Responses to DNR comments on the revised EIR, DNR letter dated December 28, 1984. April 12, 1985

CRANDON PROJECT

Responses to DNR comments on the Revised
EIR, DNR Letter Dated December 28, 1984

FIGURE 1.1-5

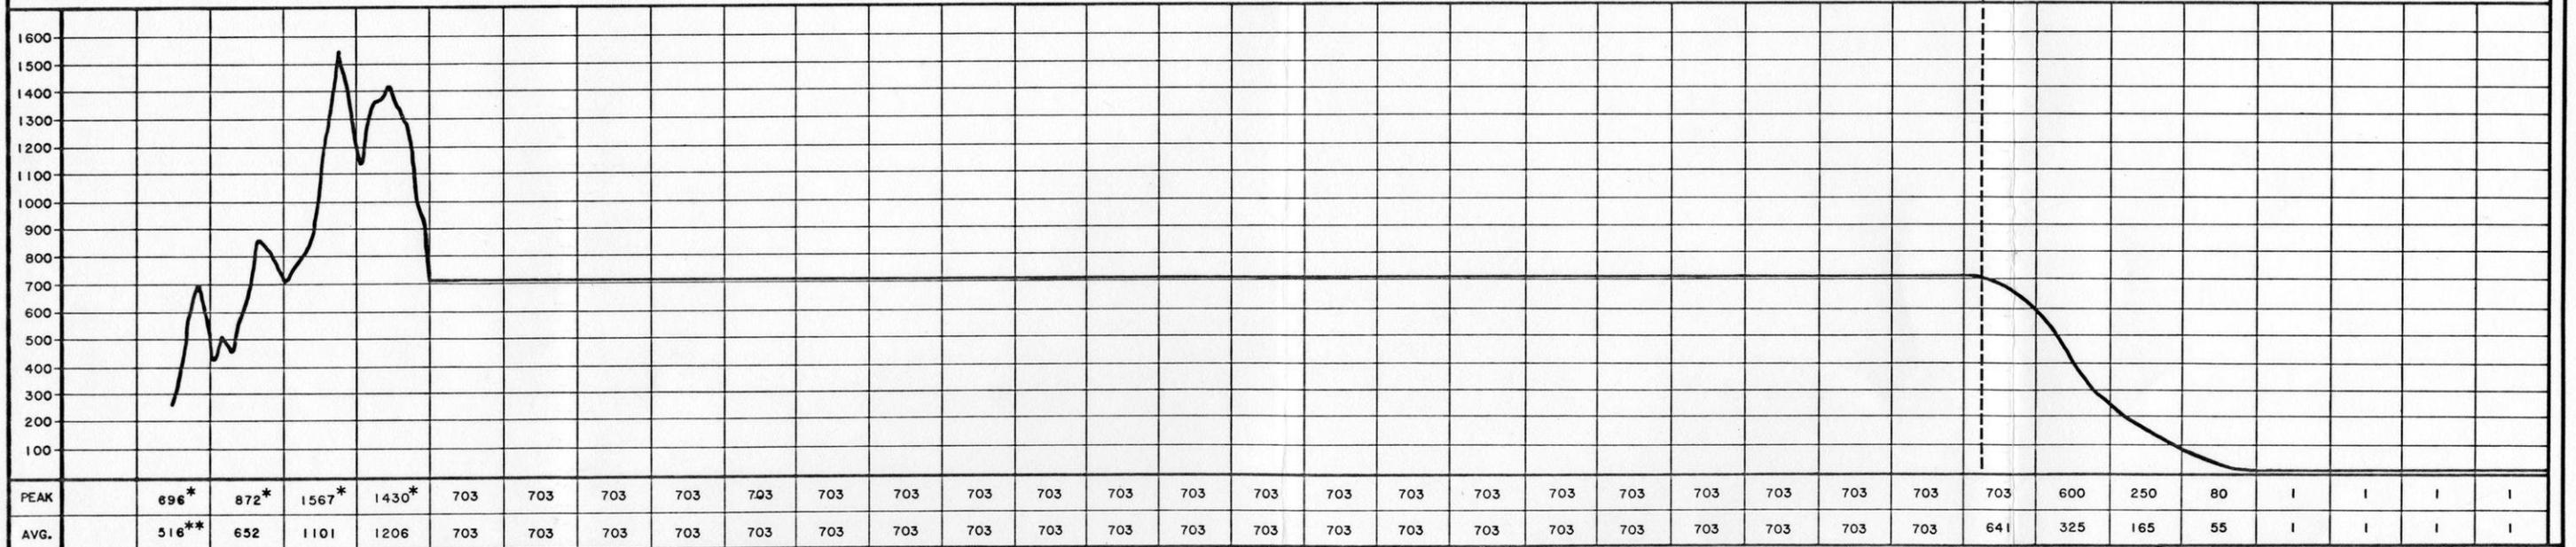
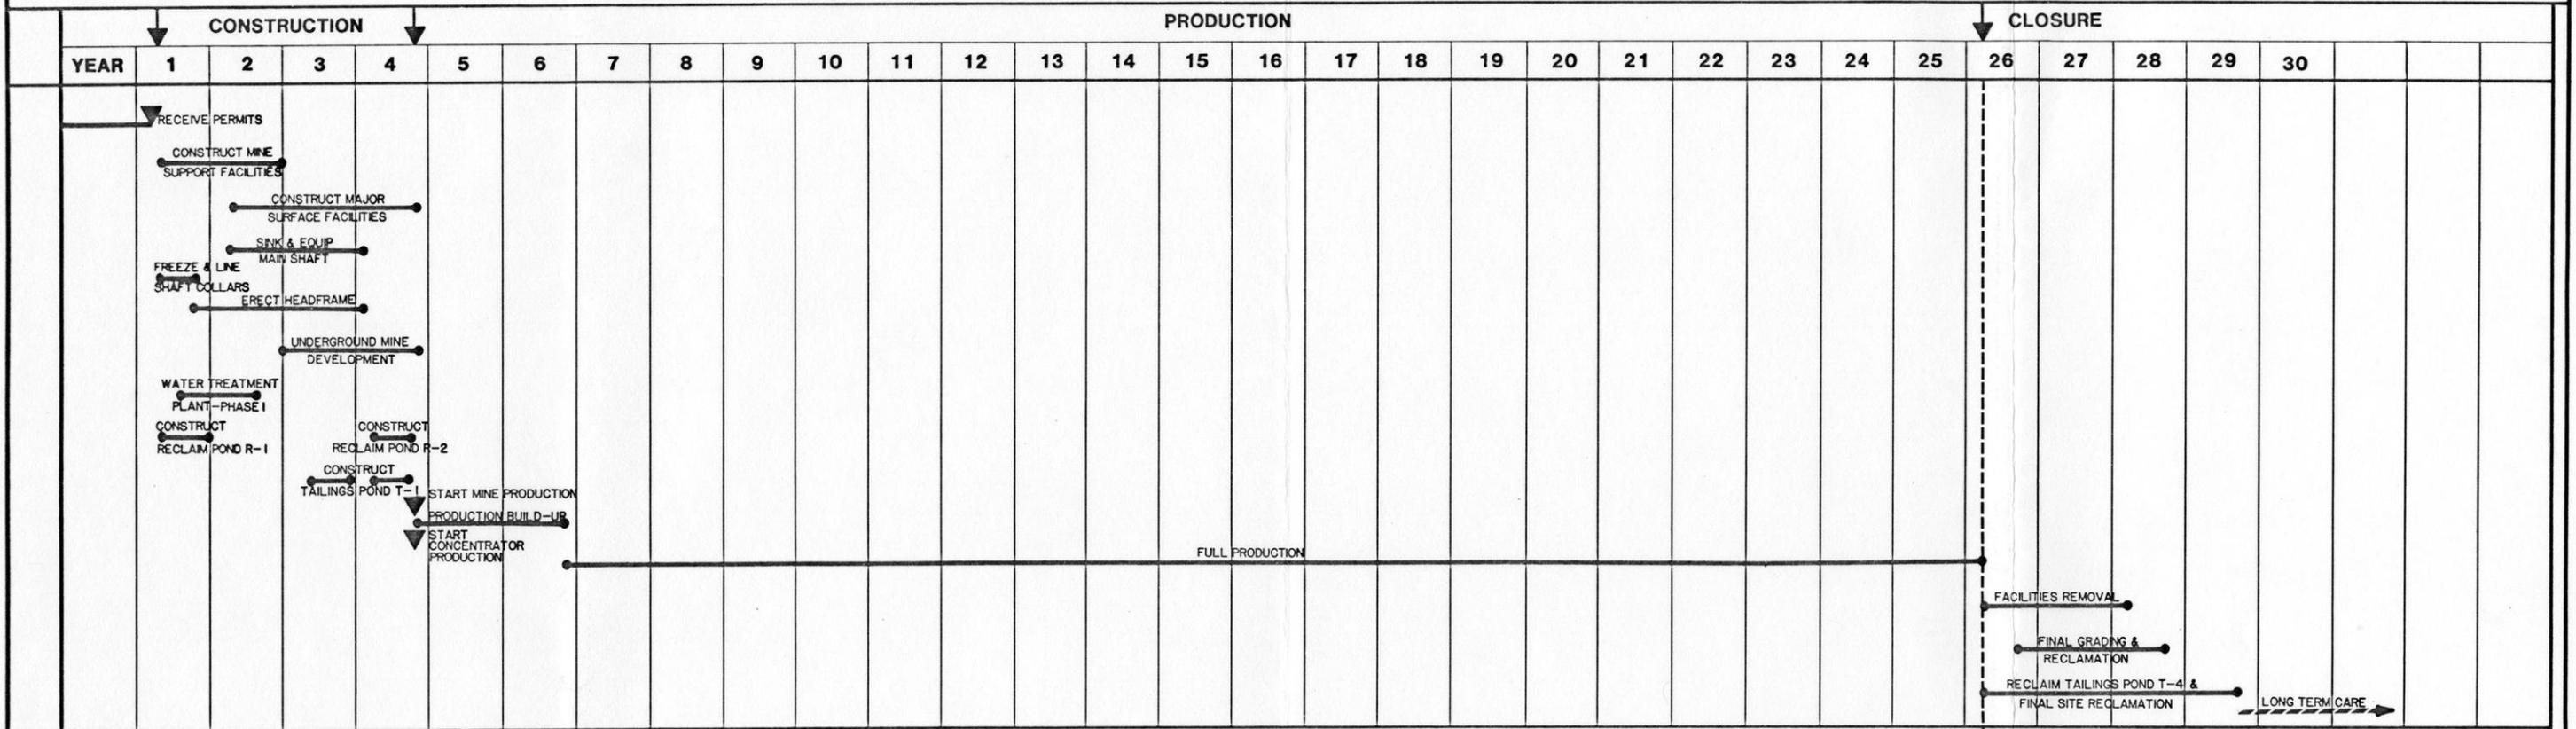
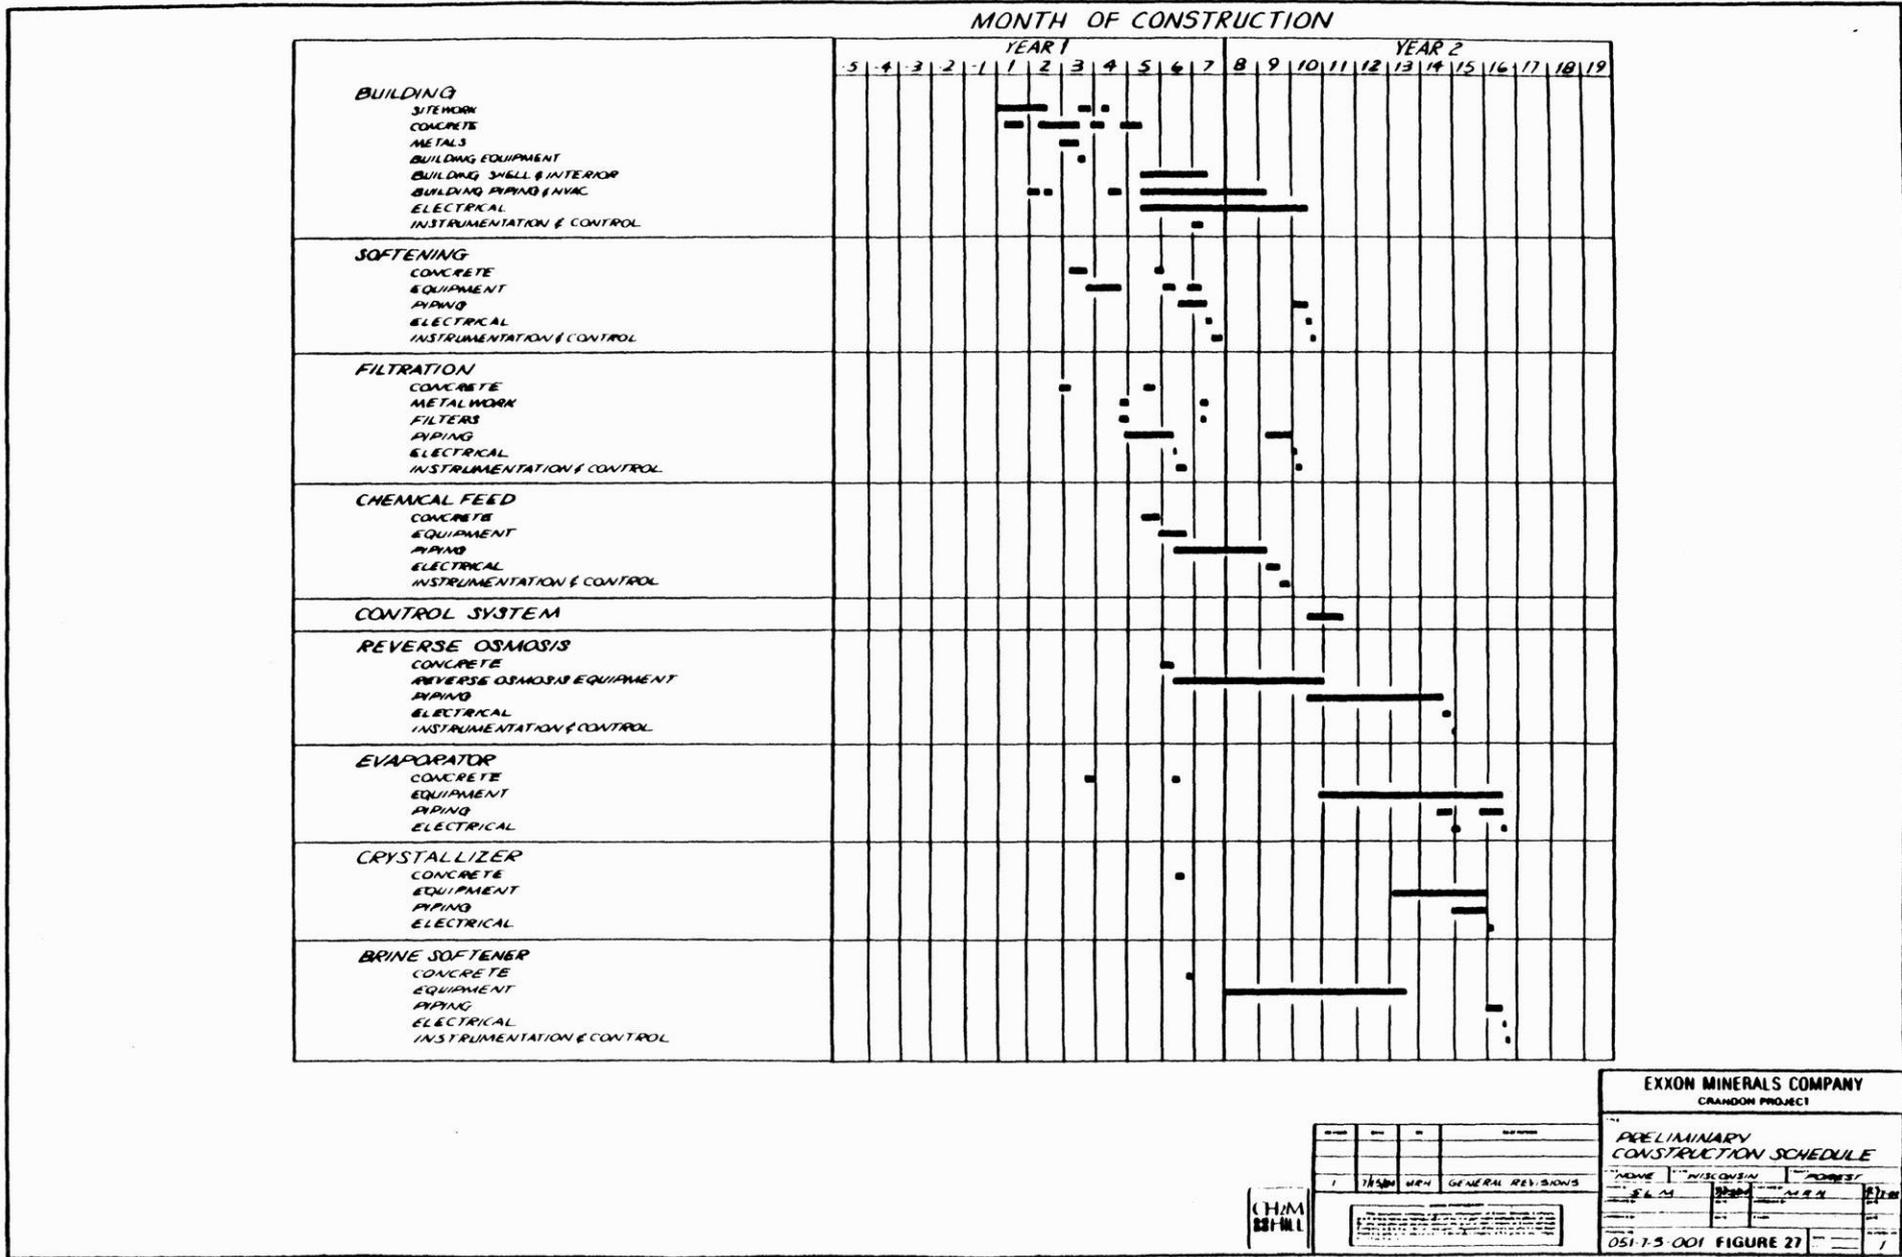
Figures 1.1-15 and 1.3-19 show the construction schedule for the entire project, including that for the wastewater treatment plant (WTP) and the reclaim ponds. These schedules differ significantly from that presented for the WTP in the Preliminary Engineering Report dated October 19, 1984. Which is the correct schedule? Is there an updated EIR project schedule available?

It is presumed that the above referenced figure is 1.1-5 as there is no Figure 1.1-15.

Figures 1.1-5 and 1.3-19 from the revised EIR showing the Project construction schedules have been updated and are consistent with the wastewater treatment plant (WTP) Preliminary Engineering Report dated October 19, 1984. The updated Project schedules were contained in the February 1985 revision to Chapter 1 of the EIR which was previously submitted to the DNR. Copies of these figures are attached.

CRANDON PROJECT MINE DRAINAGE SCHEMATIC

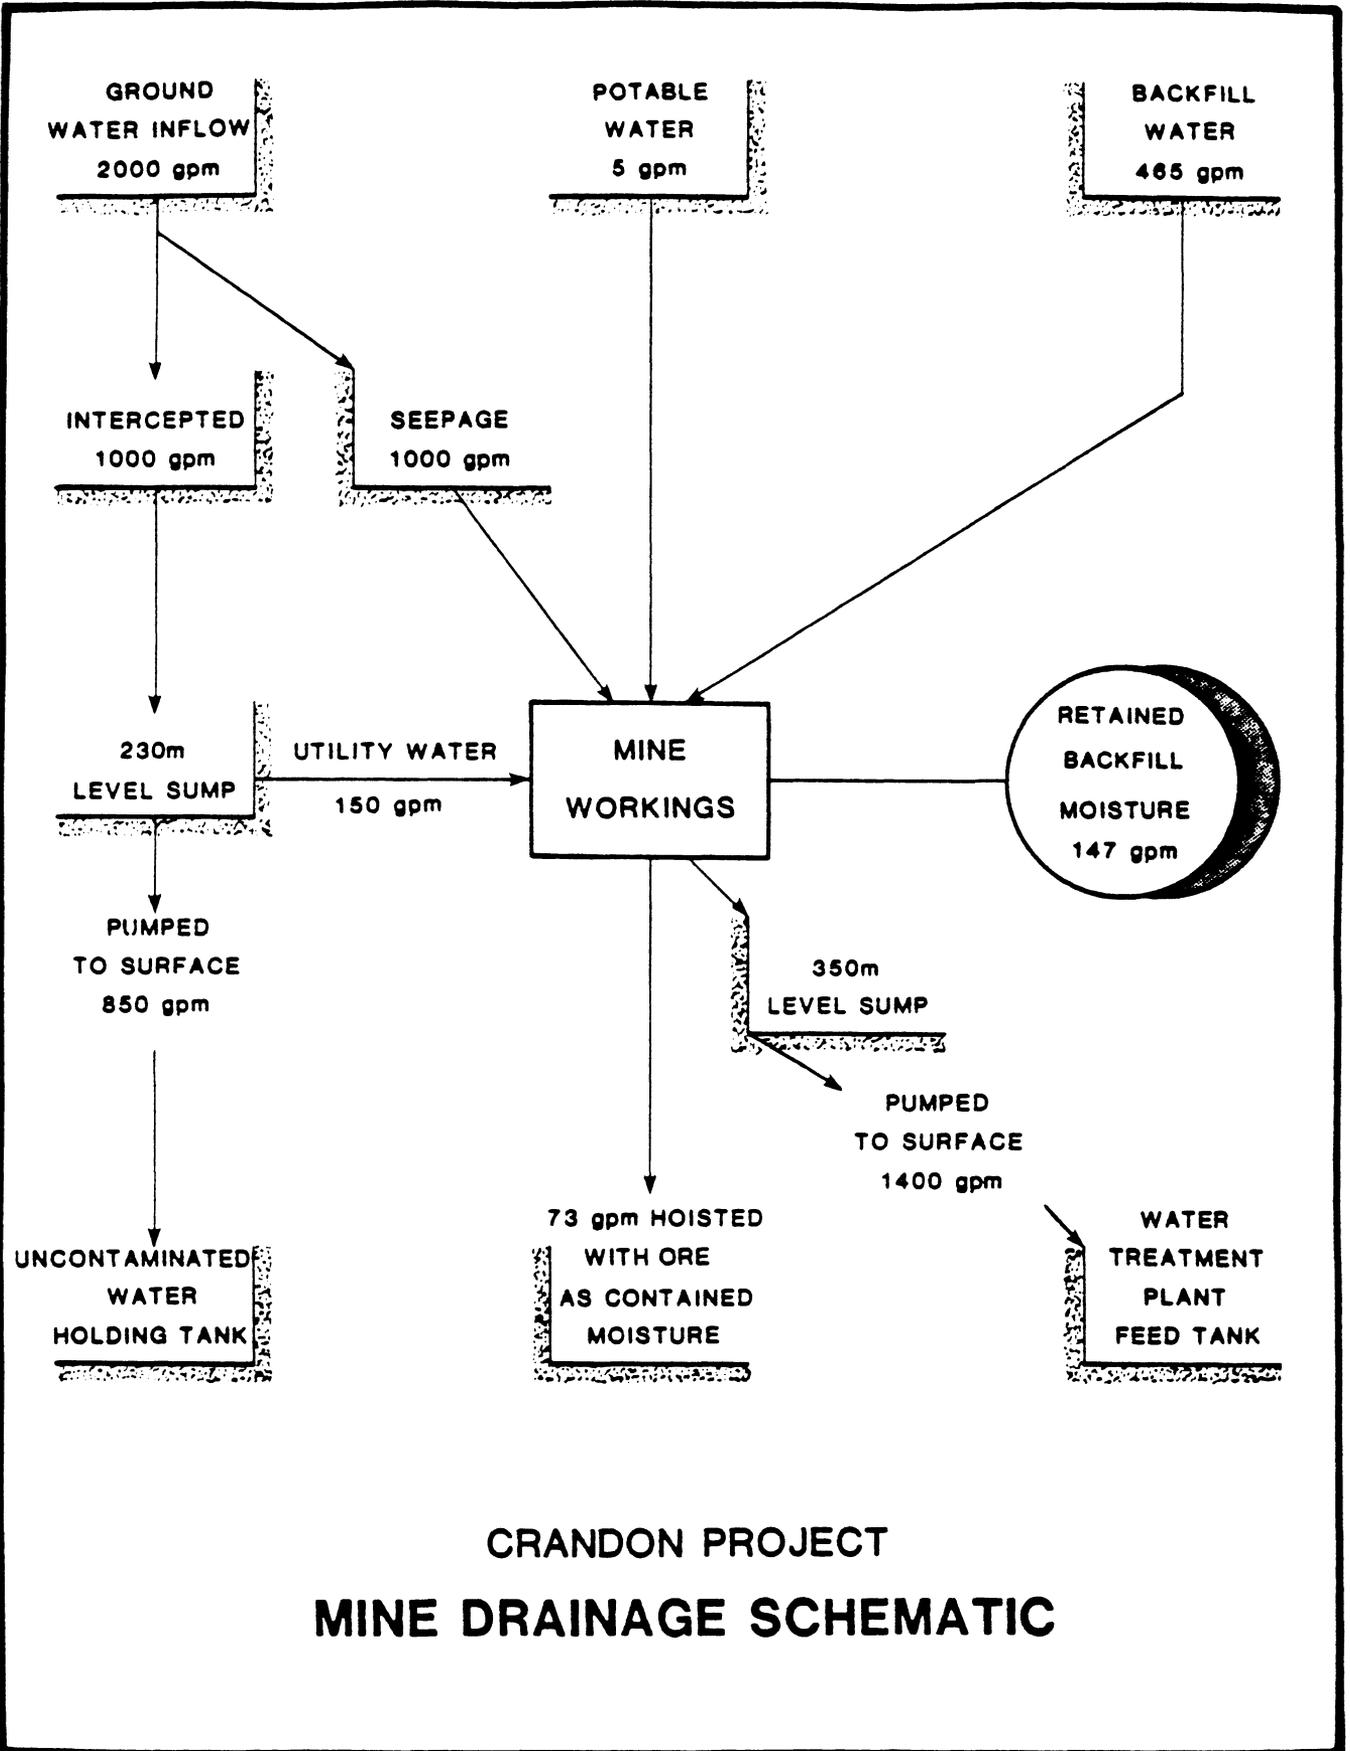
The 2,000 gallons per minute cited for site area impact modelling and system design is inconsistent with the revised Appendix 4.1A. A maximum of 1,600 gallons per minute was used for impact modelling and it is unclear what figure was used for mine water handling system design.

The mine pumping and drainage design basis, depicted on the attached Figure 1, provides for a steady state ground water inflow of 2,000 gallons per minute or 25 percent more than the steady state inflow range of 934 to 1,592 gallons per minute predicted by the mine inflow computer modelling (D'Appolonia, 1984). Mine pumping systems have been designed for a total capacity of 2,600 gallons per minute to account for other mine water flows such as backfill water drainage, potable water, utility water, bedrock storage depletion and minor downtime on the pumps. Each operating pump will be backed up by an installed spare. Dual full capacity pump discharge columns to the surface will be provided.

Refer to the High Capacity Well Approval Application for the Underground Mine for further discussion of mine water handling system details.
